NOVI-TEN PRO JZ23-09

JZ23-09 NOVI-TEN PRO WITH REZONING 18.740

Public hearing at the request of Novi-Ten Associates for Planning Commission's recommendation to City Council for a Zoning Map Amendment from Light Industrial and Office Service to Low Density Multiple Family and Community Business with a Planned Rezoning Overlay. The subject site is approximately 34-acres and is located east of Novi Road, south of Ten Mile Road (Section 26). The applicant is proposing to develop a 71-unit multiple-family townhome development on the RM-1 portion, and approximately 35,900 square feet of commercial space on the B-2 portion.

REQUIRED ACTION

B2 COMMUNITY BUSINESS ZONING SITE PLAN

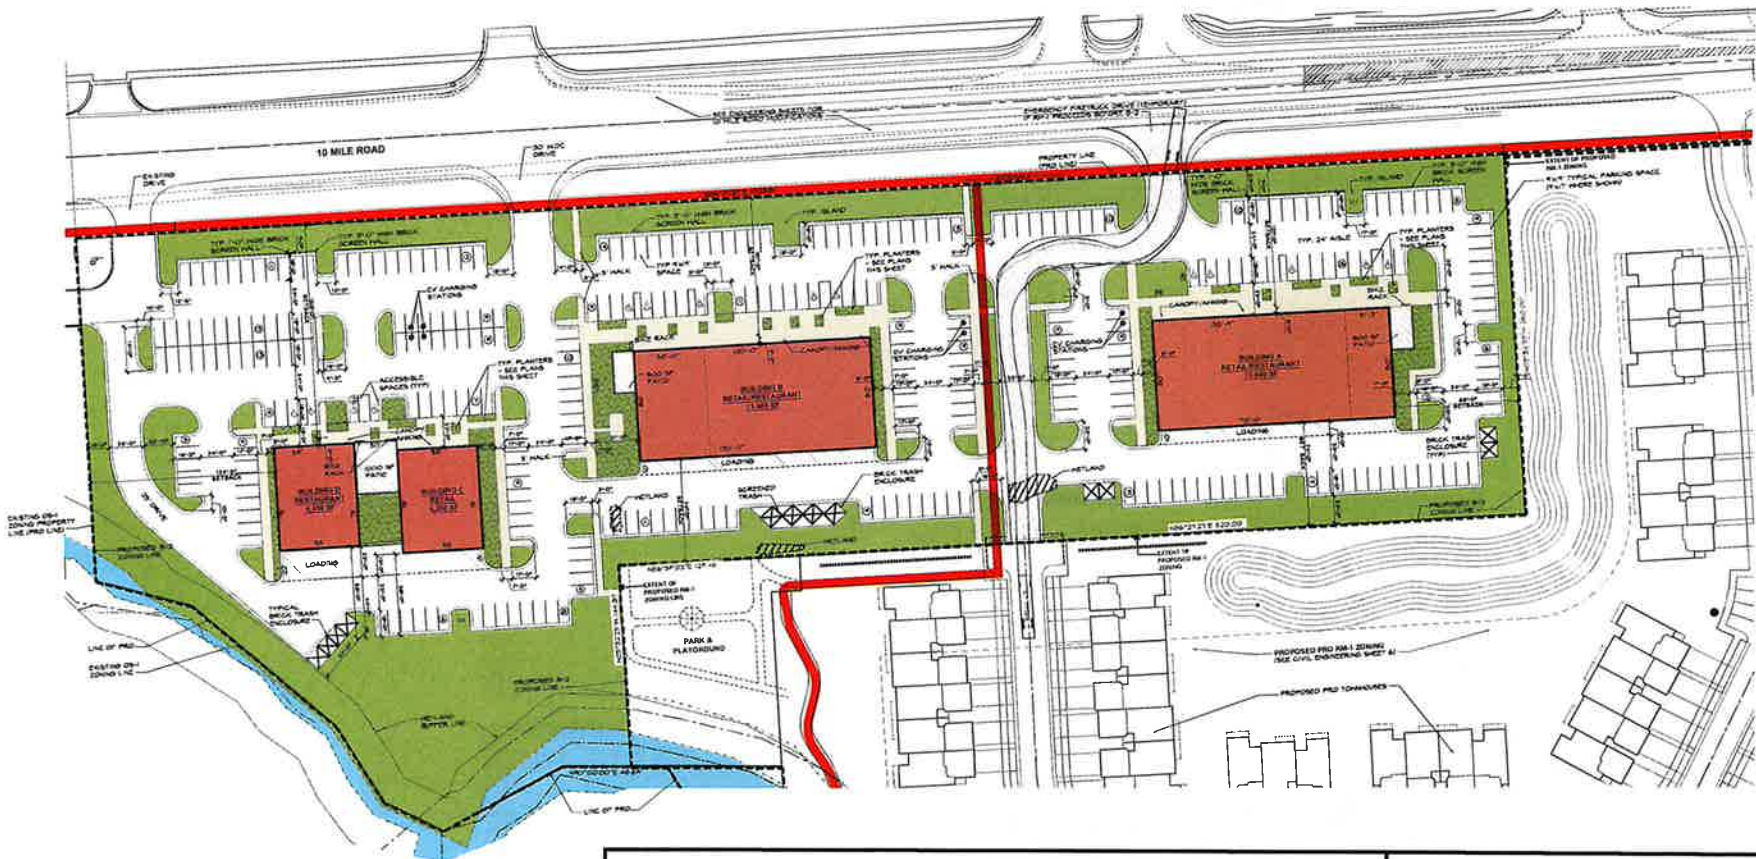
side and allow the planter landscaping to count toward foundation requirements. However, Buildings A, C and D are only slightly deficient, so the waiver is supported. The applicant states Building B landscaping will be increased to lessen the deviation or eliminate it.

As requested, the June 17, 2024 submission has eliminated the drive-thru restaurant. This is shown on Drawing Sheet P.5.

WOODLAND SUMMARY

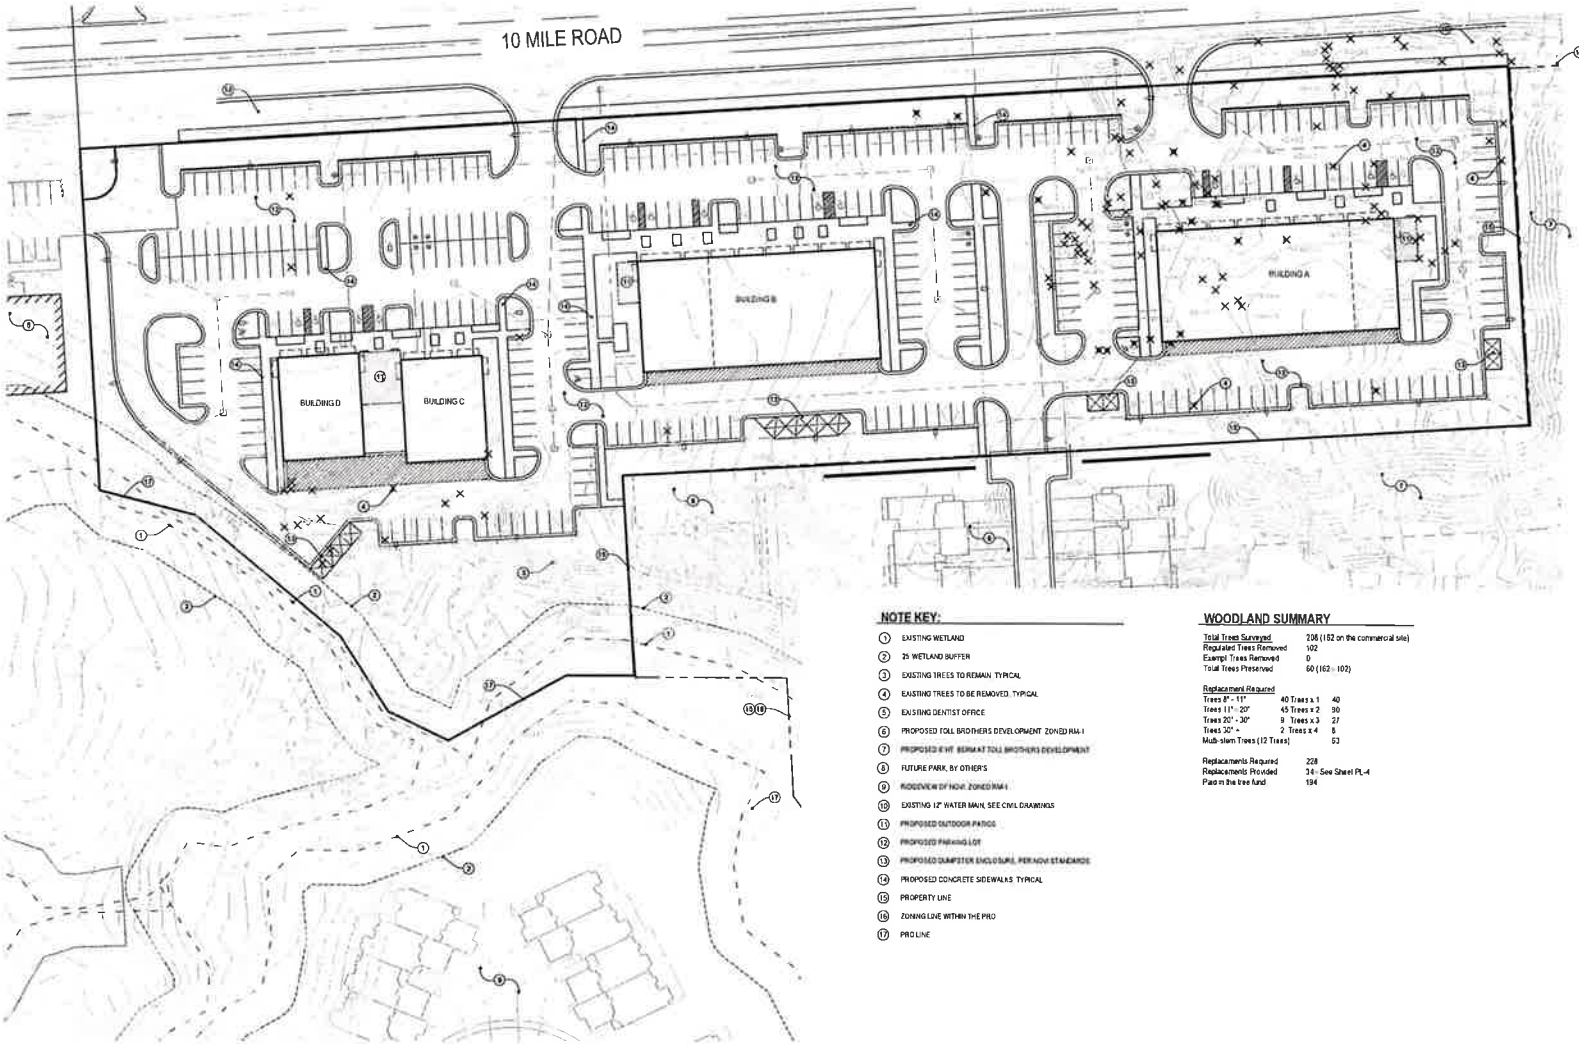
- Sheet PL-1 lists that 102 regulated trees will be removed but the sum of trees listed under the required replacements section is 108 trees (40+45+9+2+12). A potential error in summing the number of trees removed may have occurred. However, this does not impact the number of replacements required.

- a. The cost to stake, install, and remove the tree protection fencing should be added to Sheets PL-1 and RL-3 in order to calculate woodland fence inspection fees.

- b. The location and extent of tree protection fence should be added to the commercial site plan prior to final site plan approval; locations and diagrams of tree protection fencing have been included in the residential site plan. This can be added to Sheet PL-1 for the commercial site plan.
